To: Jesse Bacon, Superintendent *[Signature]*
From: Bret Highley *ABH*
Date: April 26, 2019
Re: Change Order #30
Maryville Elementary Addition/Renovation

Change Order

PROJECT: <i>(Name and address)</i> Maryville Elem School Addition / Renov. 4504 Highway 44 East Shepherdsville, Kentucky 40229	CONTRACT INFORMATION: Contract For: General Construction Date: August 17, 2015	CHANGE ORDER INFORMATION: Change Order Number: 030 Date:
OWNER: <i>(Name and address)</i> Bullitt County Board of Education 1044 Highway 44 East Shepherdsville, KY	ARCHITECT: <i>(Name and address)</i> Sherman Carter Barnhart Architects PLLC 2405 Harrodsburg Road Lexington, KY 40504	CONTRACTOR: <i>(Name and address)</i> Parco Construction Company 2521 Ridgemark Court Louisville, KY 40269-0339

Re: Maryville Elementary School
BG #15-106
SCB PR # 15
Water Softener for Domestic
Water System
Parco RFP # 1535-40

ALE
P5.0

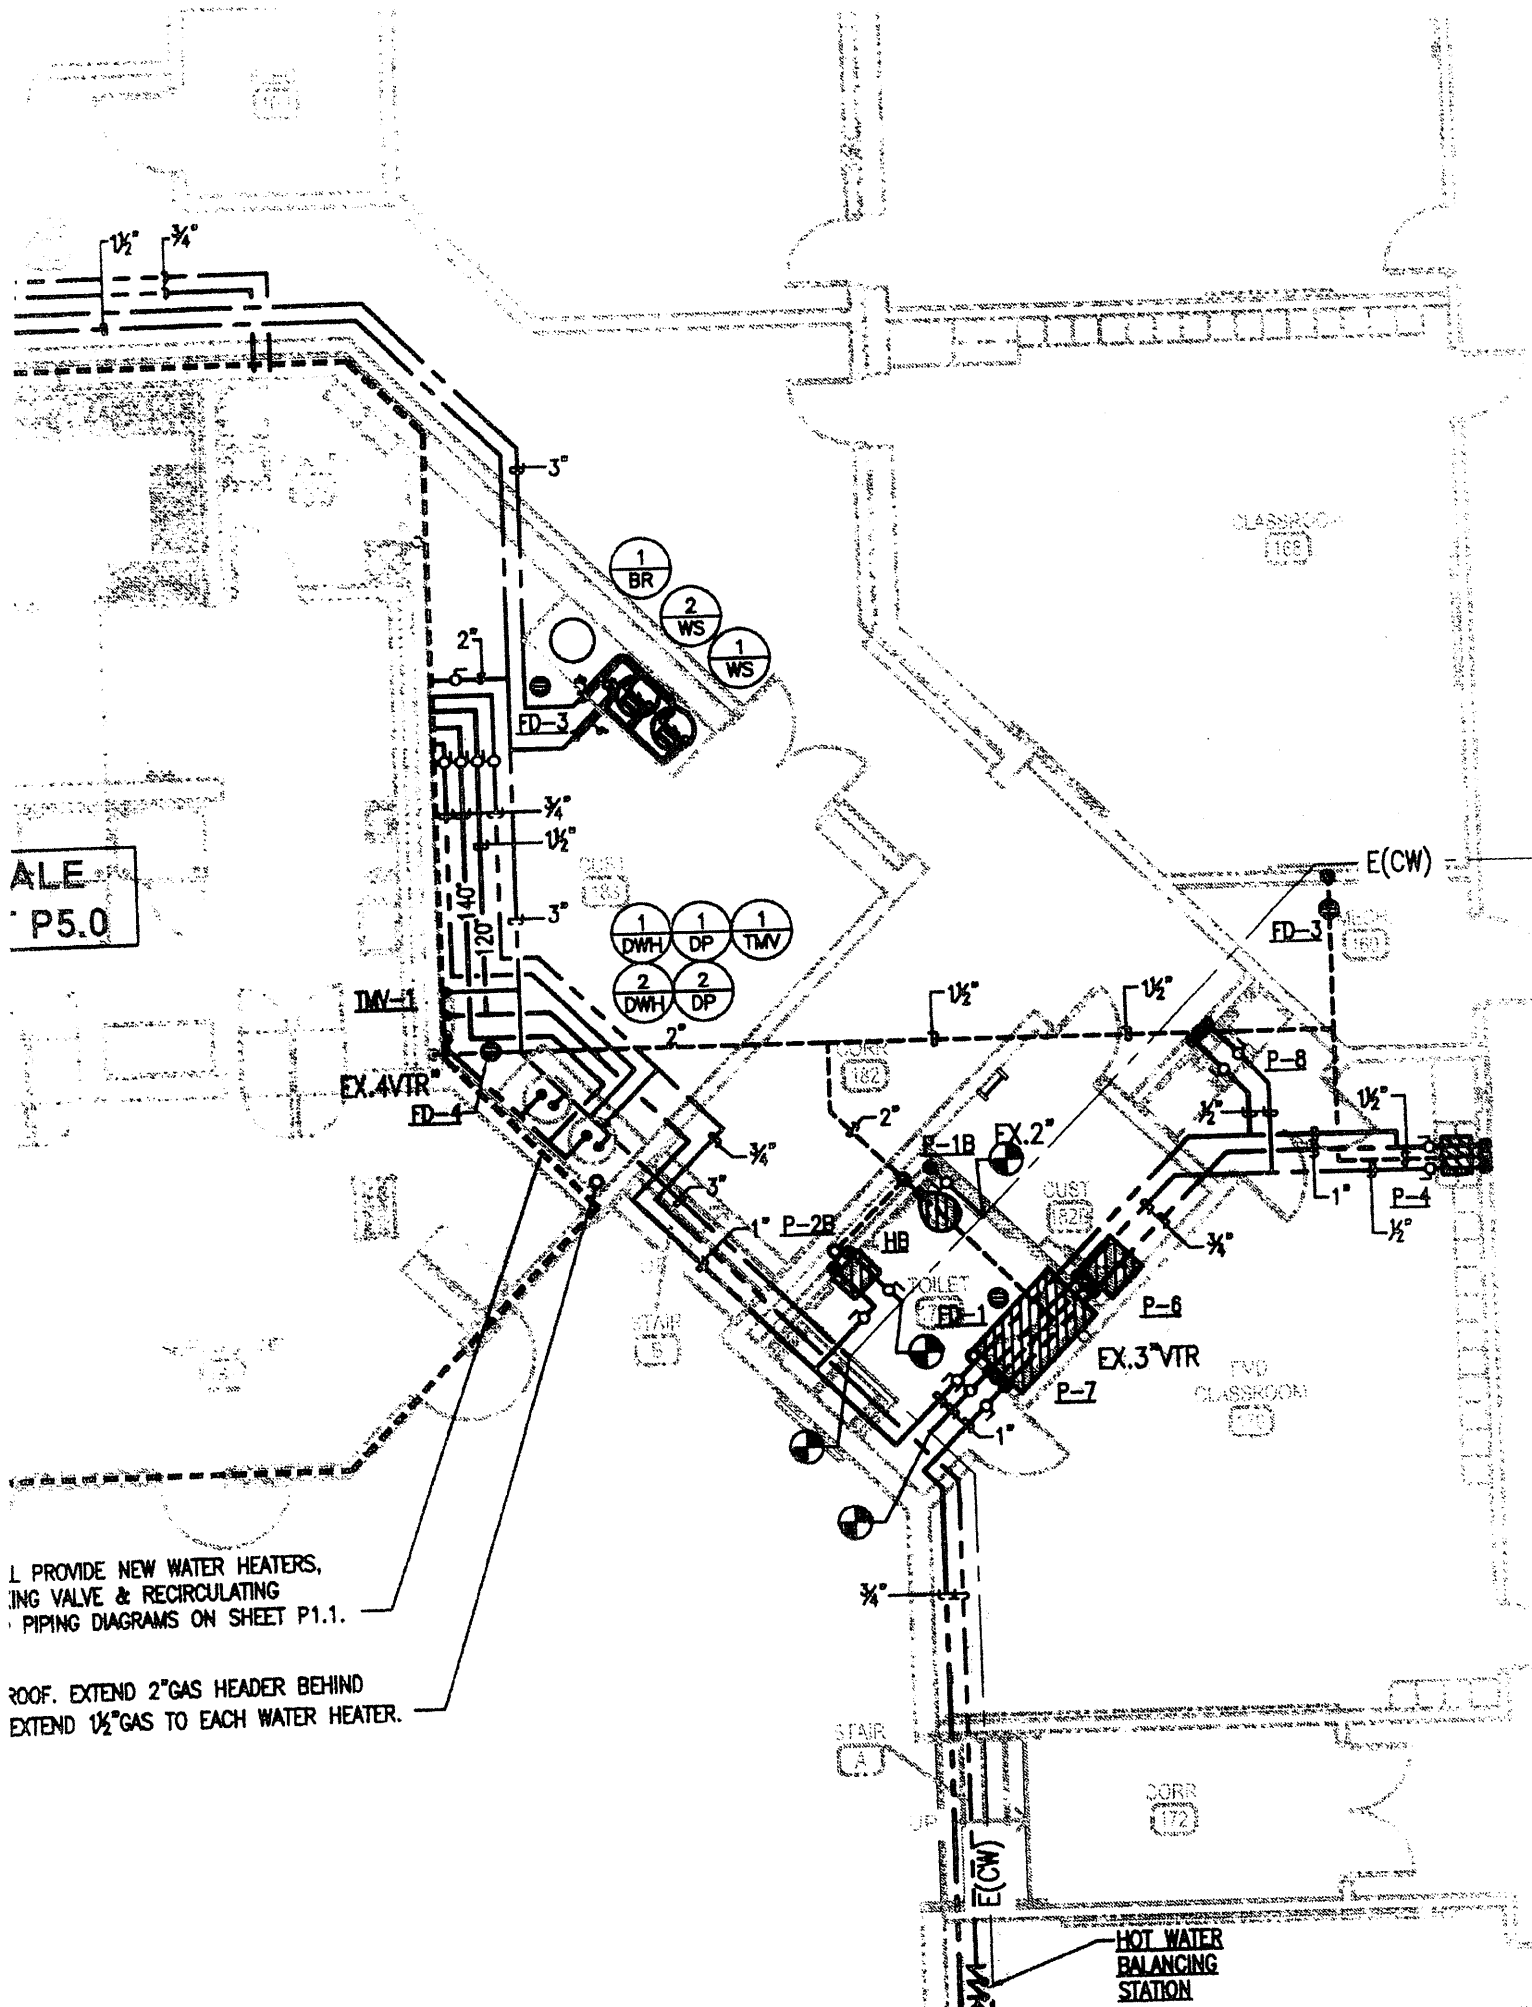
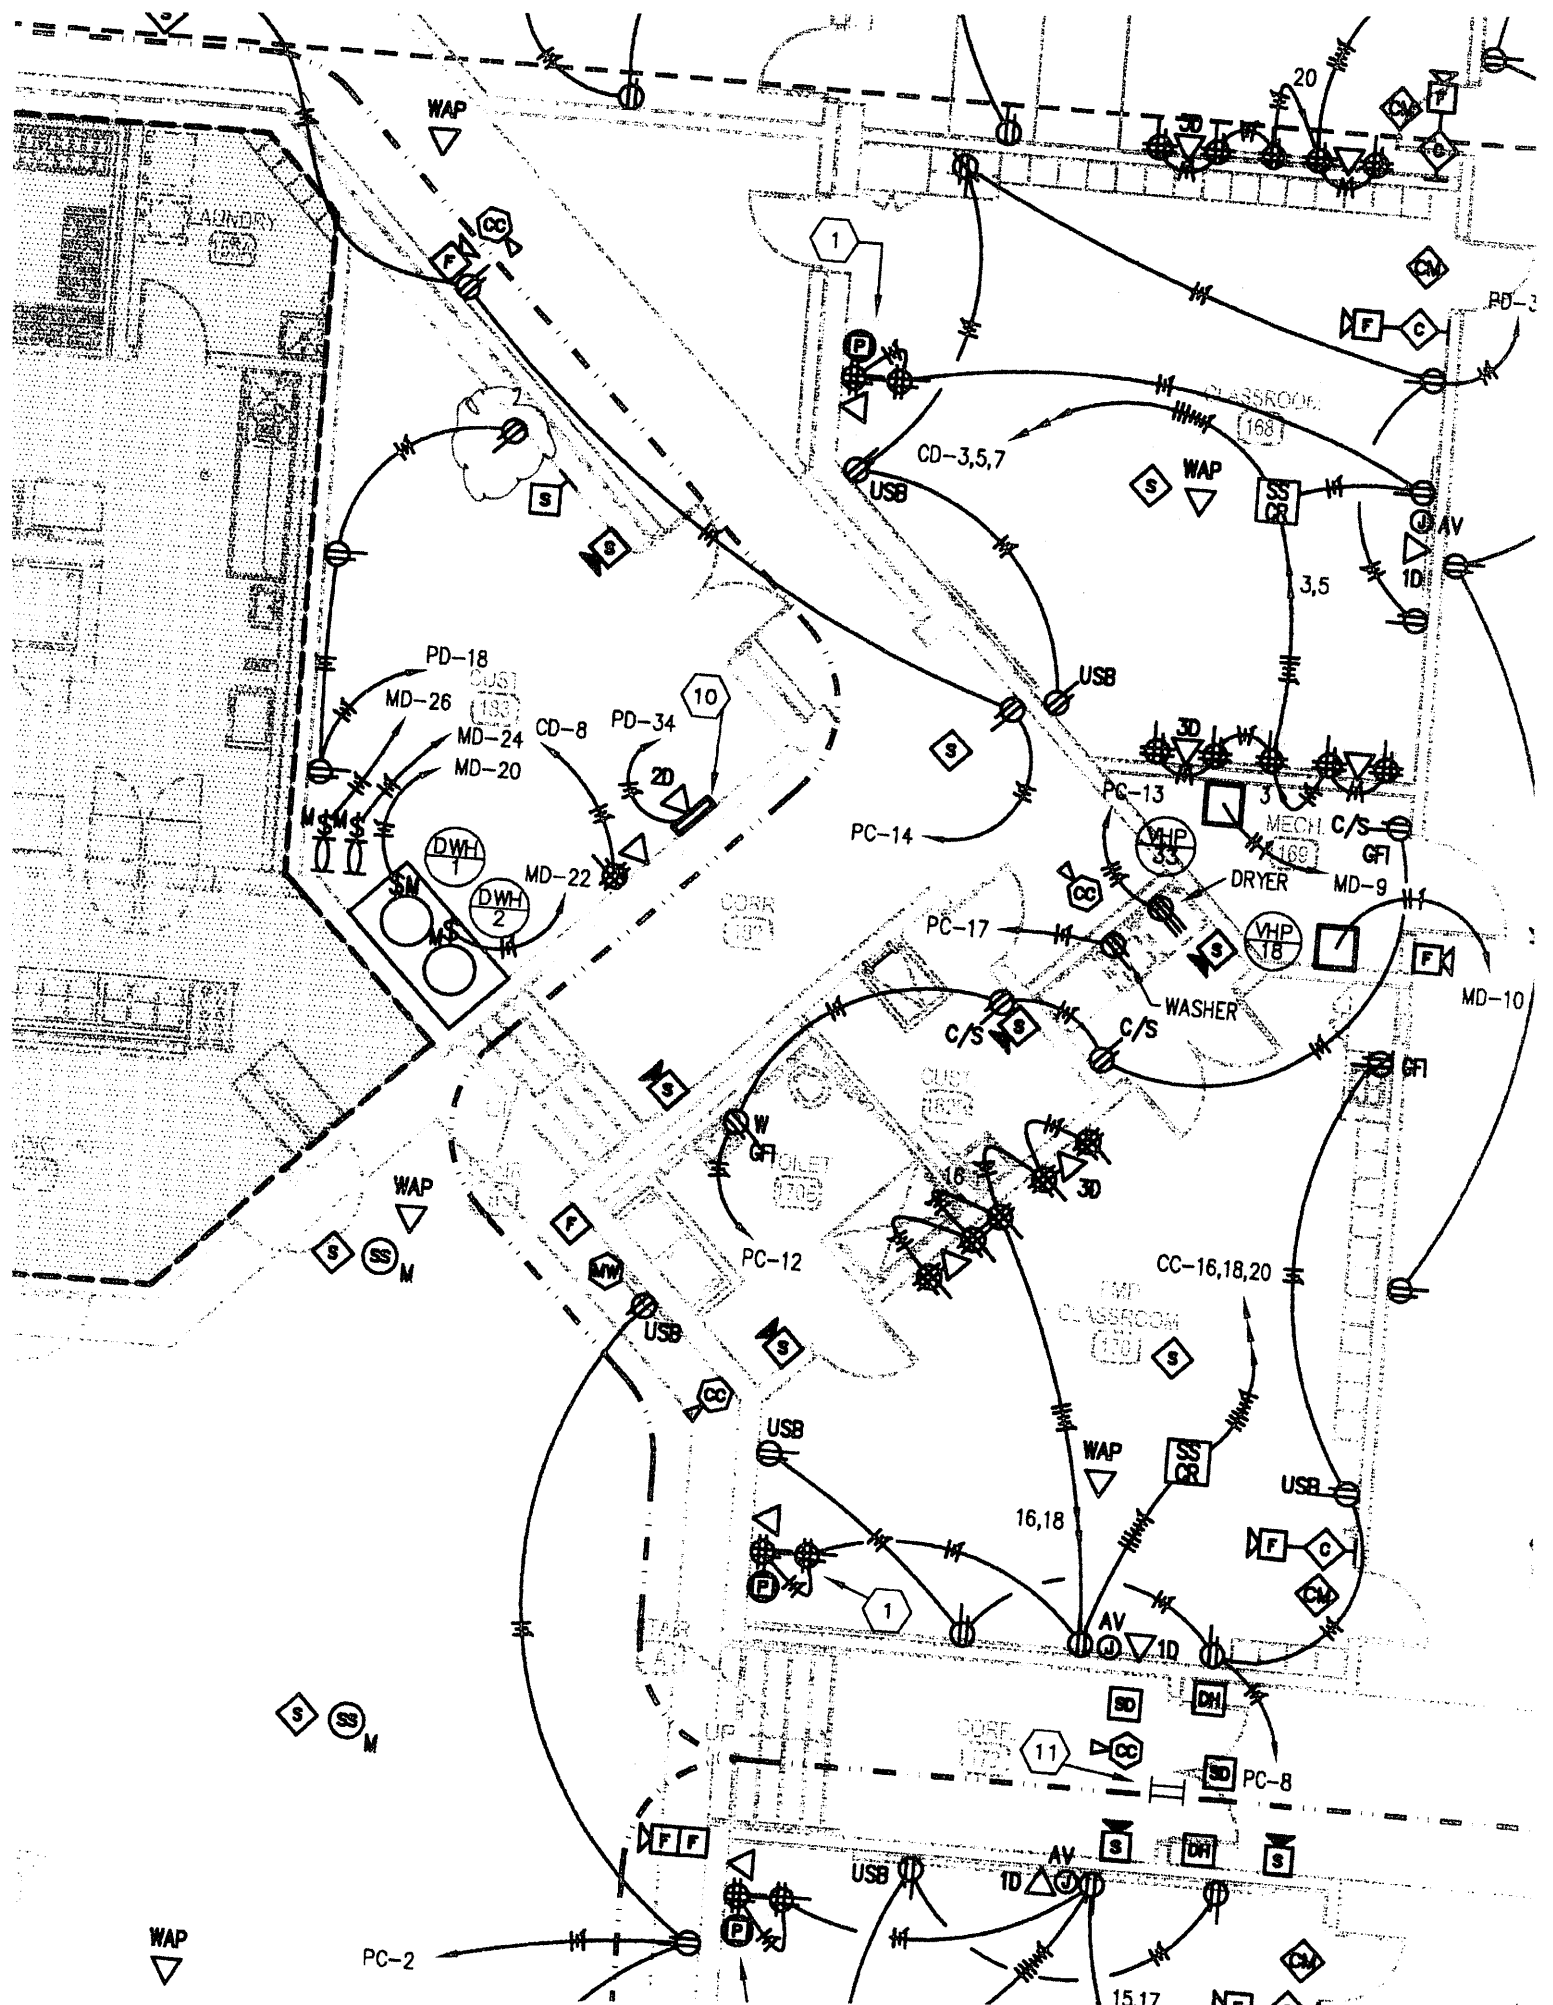
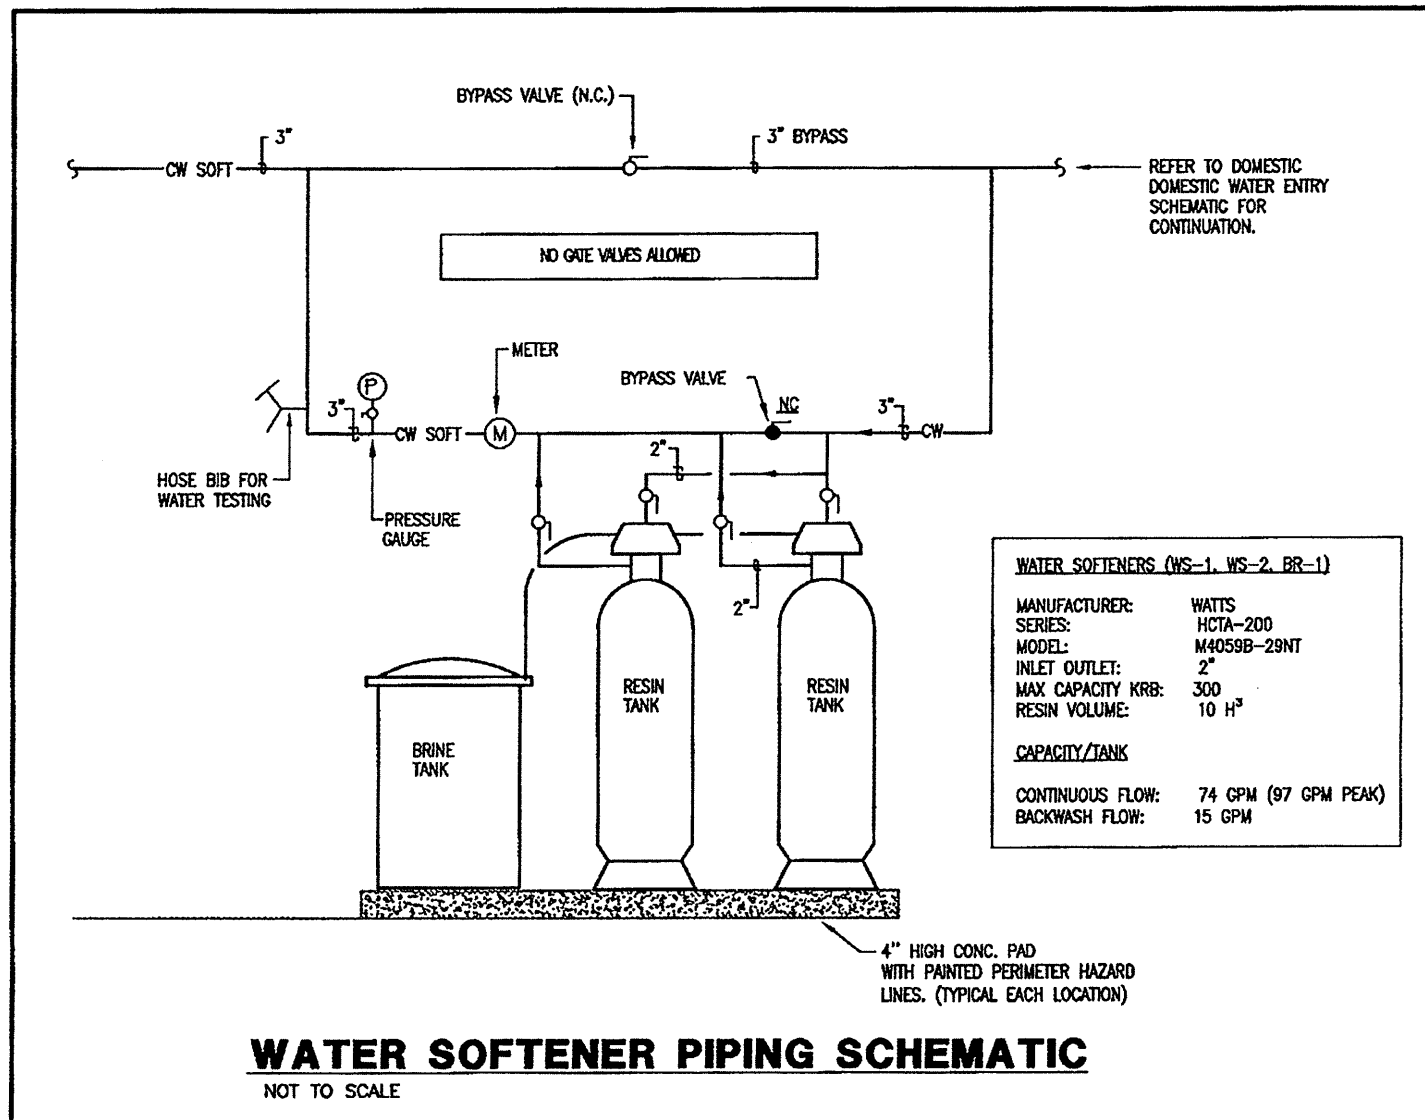
Water softener for the domestic water system, refer to attached backup and pricing information for details.

In accordance with your request, we offer the following quote for furnishing and installing (1) Watts Duplex Water Softener per the submittal Q-713 dated 4-5-19. Our quote includes piping the unit per the detail on drawing P1.1 dated 6-15-15 as prepared by CMTA.
